Addendum No. 4

Reference: New Ogden Second District Juvenile Court
Administrative Office of the Courts – Ogden, Utah
DFCM Project No. 08284150

Addendum 003

project:	Ogden Juvenile Courthouse	**project no:**	12500
date:	2013-09-10	**no. pages:**	35
owner:	Administrative Office of the Courts		
contractor:

6 Typical Bituminous Pavement Section

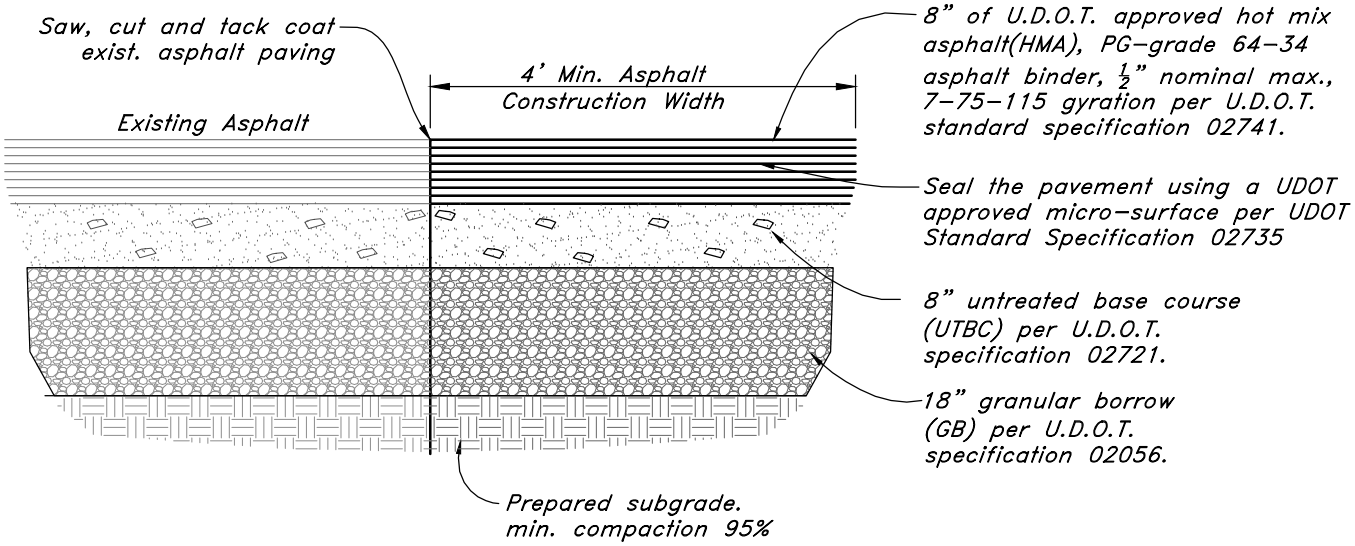
Item	Drawing No	Description
3.1	CU1.01	The fire line that enters the east side of the building will be 6" diameter C900 PVC
3.2	CD5.03	Drawing 6: Replace with the attached revised detail.
3.3		On several drawings throughout the set, two building sections are mis-referenced as C1/A305 and A1/A305. Where these references occur, Change references C1/A305 to read C4/A305 and A1/A305 to read A4/A305.
3.4	AS101	Drawing A2: Add detail call-out D2/AS500 to all four walls surrounding the generator.
3.5	A111.3B	Finish Schedule: Delete rooms 1166, 1167, 1168, 1170 from schedule. These rooms do not appear on the plans.

Note: This pavement section applies only to paving in the U.D.O.T. R.O.W. along SR-204/Wall Ave. Submittal of pavement mix design to U.D.O.T. prior to paving required. Asphalt binder to be PG-grade 64-34 or better.

A1 SB101 FOOTING AND FOUNDATION PLAN

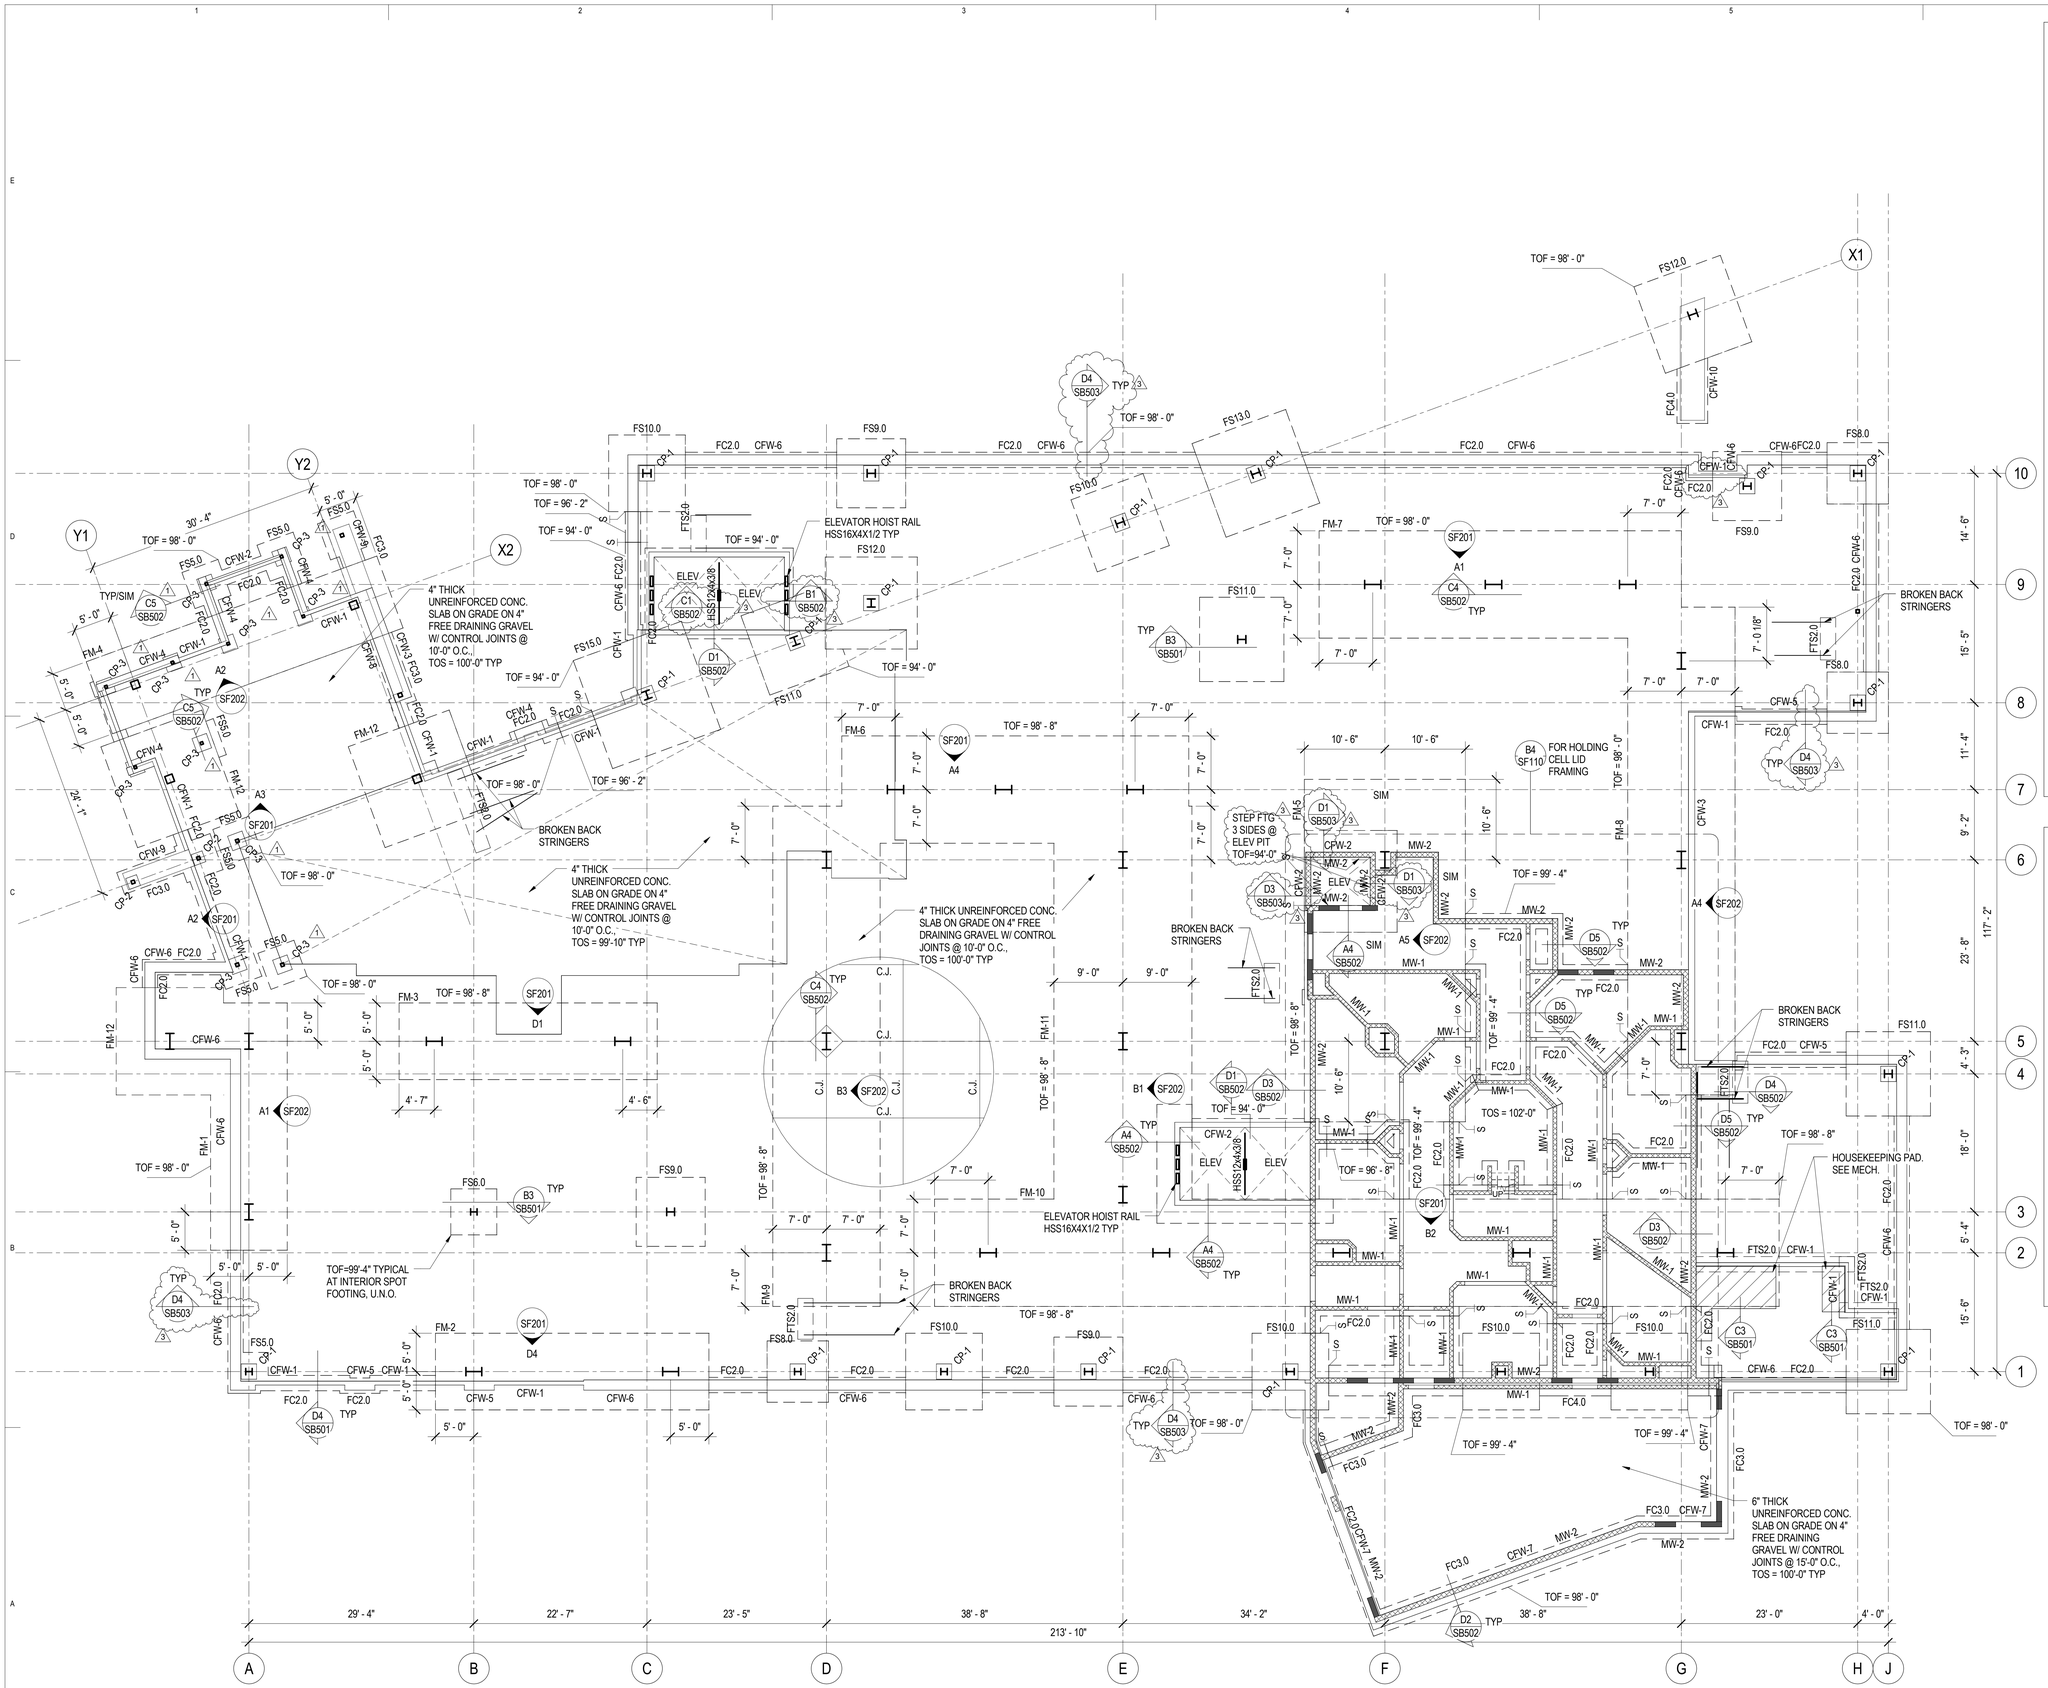
Sheet SB101
We added or revised several detail cuts. Details are to clear footing steps at the elevator pit, foundation wall, and rotating connections for the guide rails. In general clarifying existing details or added to clarify existing. There are no changes to design sizes.

SB502

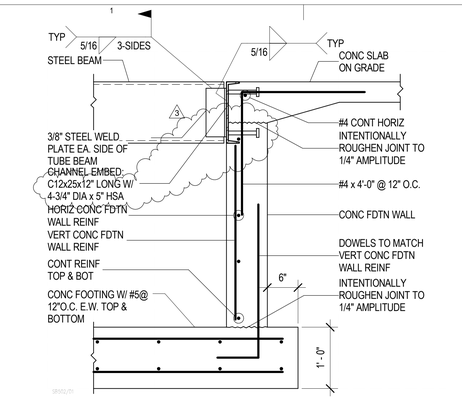
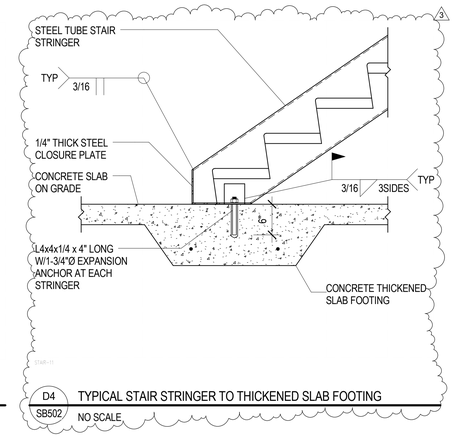
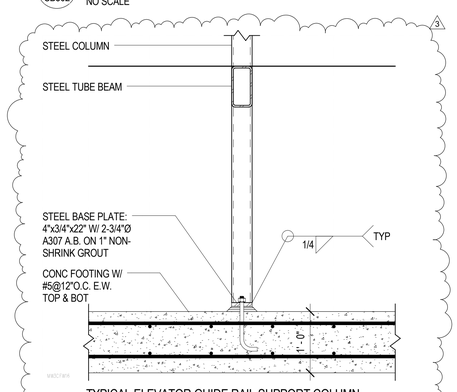
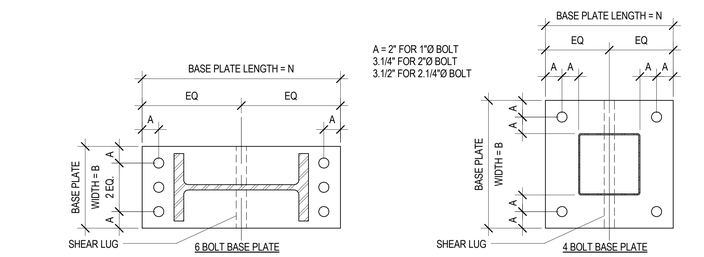
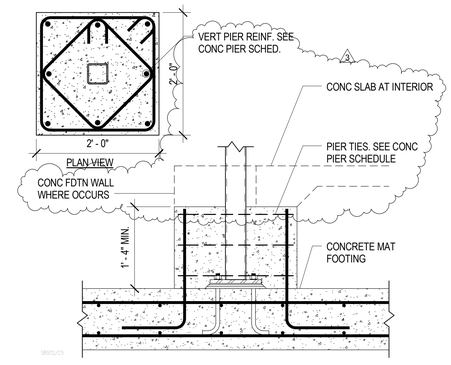
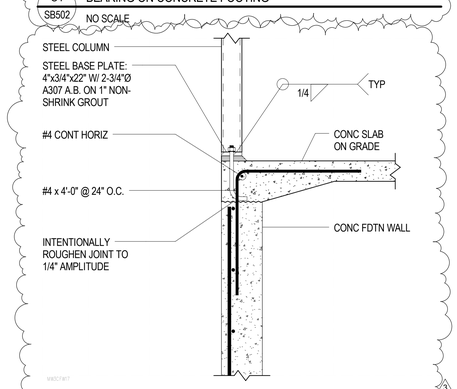
Sheet SB502
Several detail revisions. In general clarifying existing details or added to clarify existing framing. There are no changes to design sizes. Some of the changes to masonry wall were drafting changes showing more clear shading.

D1 / SB503 MAT FOOTING STEP AT ELEVATOR
NO SCALE

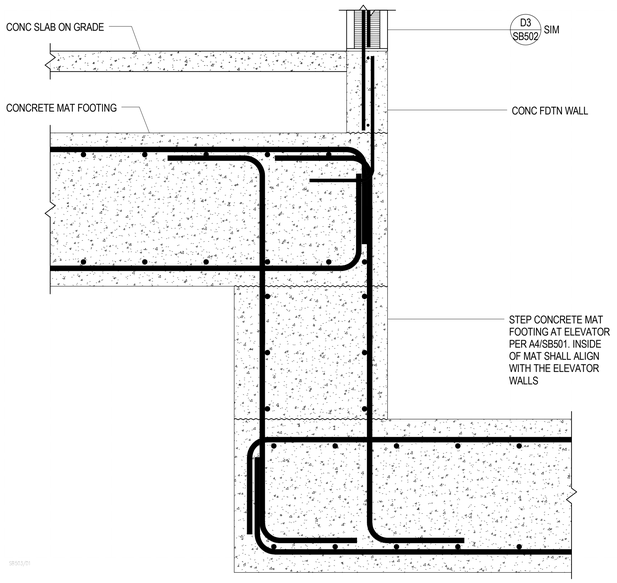
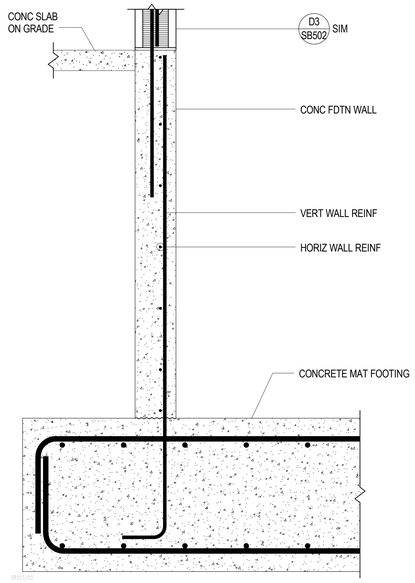
Sheet SB503
Added foundation details, showing clarifications mentioned on page SB101.

A1 SF102 LEVEL 3 FLOOR FRAMING PLAN

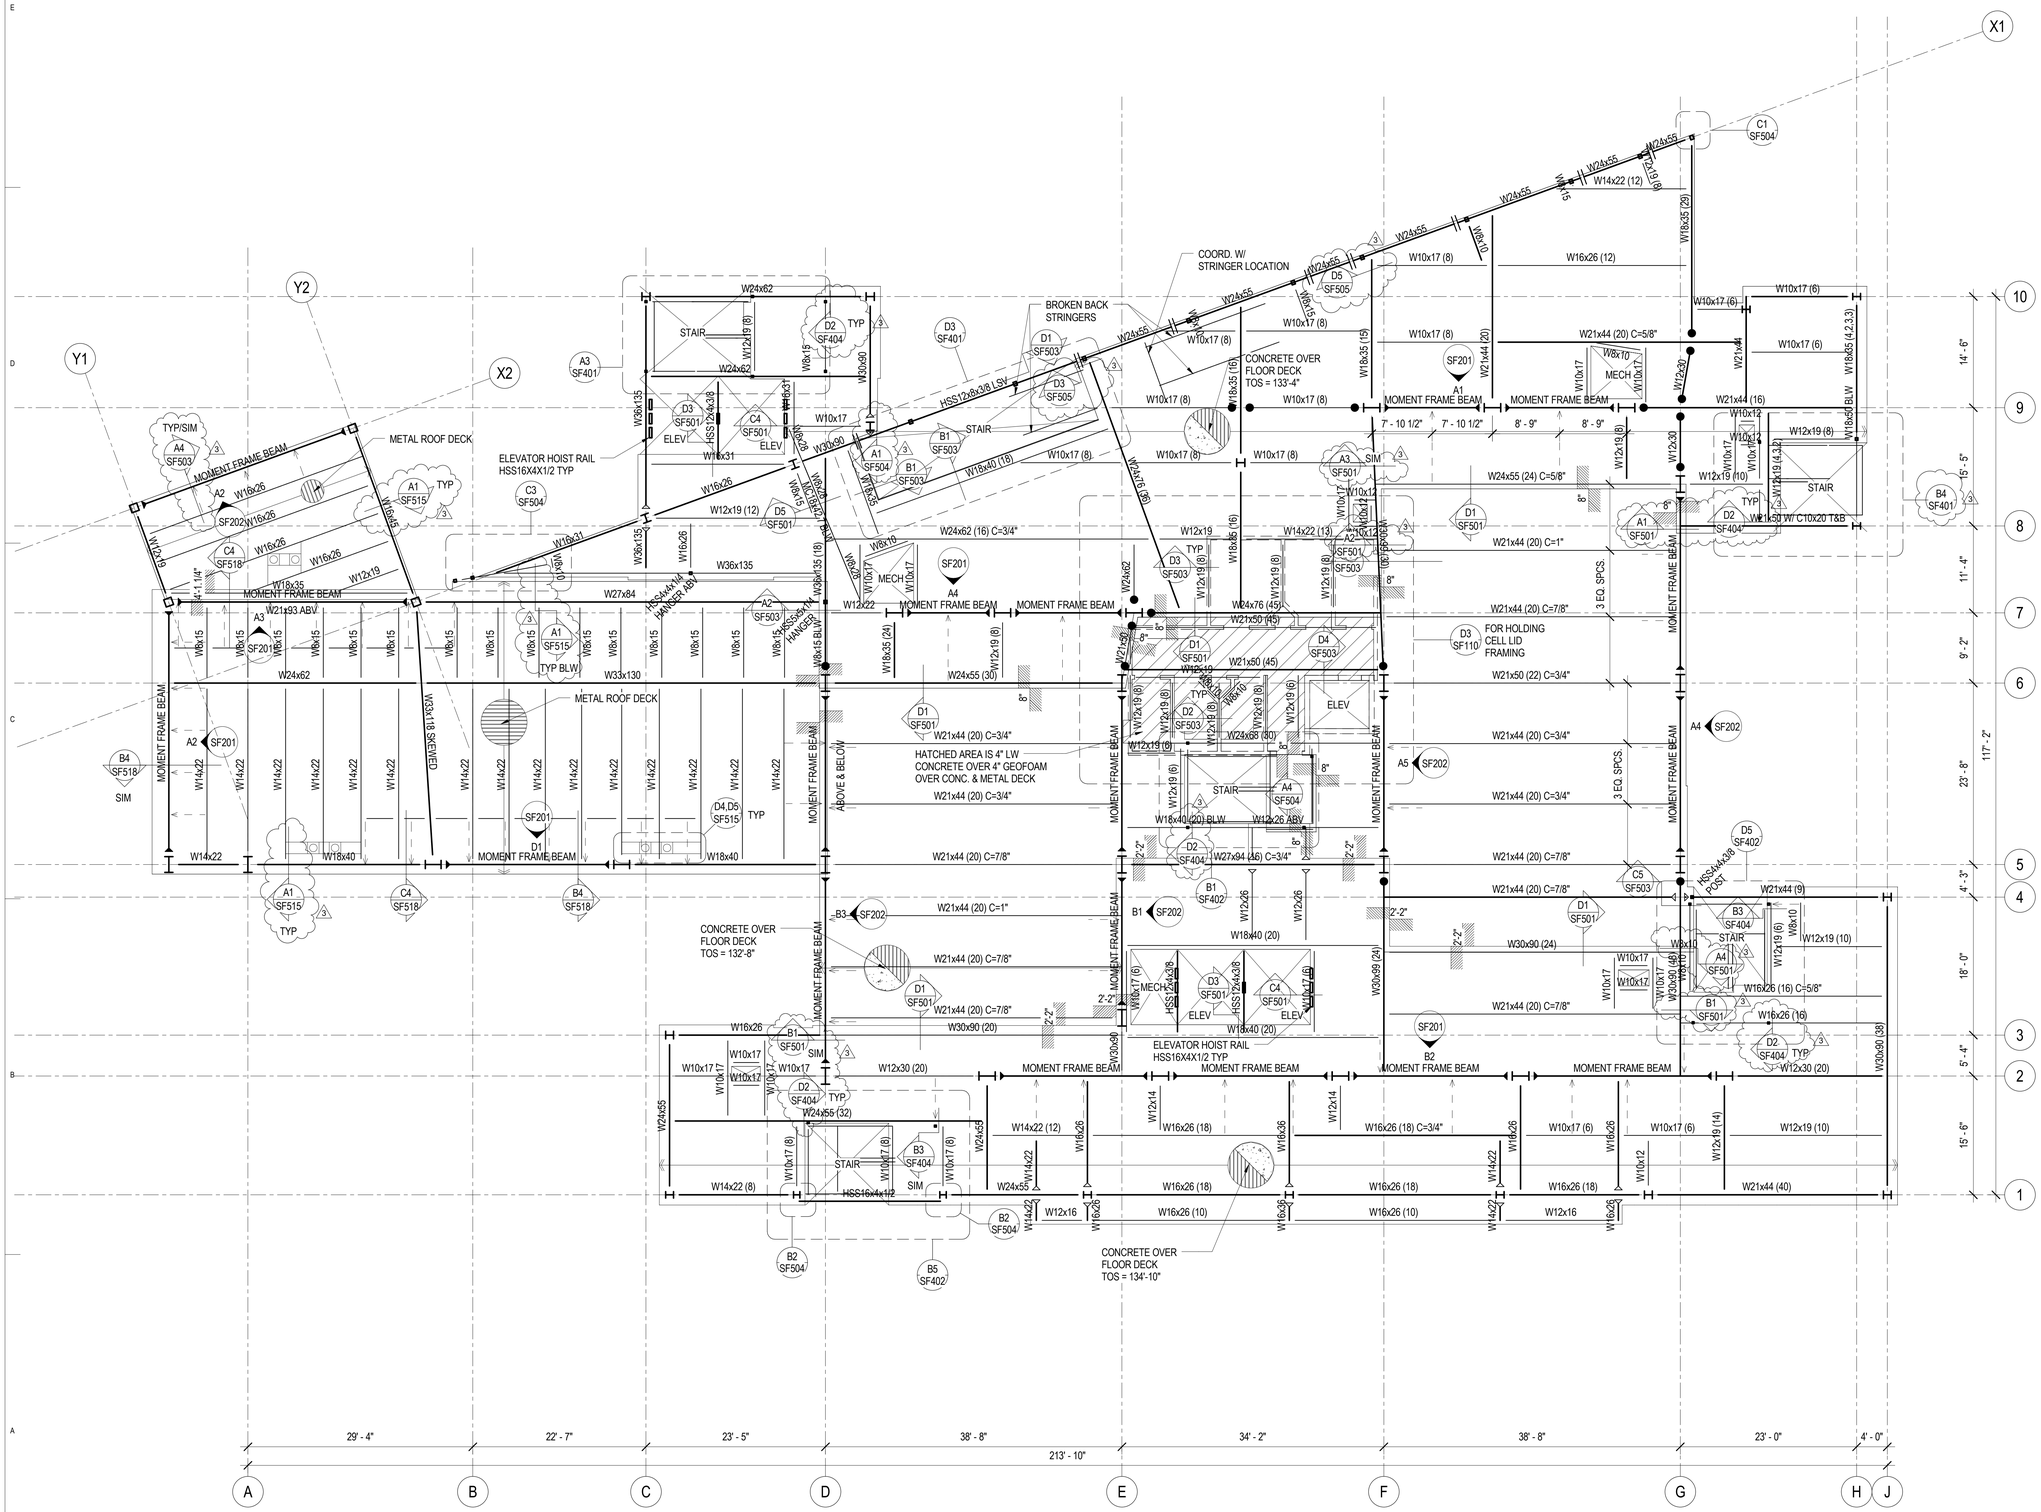
Sheet SF102 to SF104
Several details cuts added or revised clarifying existing details or added to clarify existing.
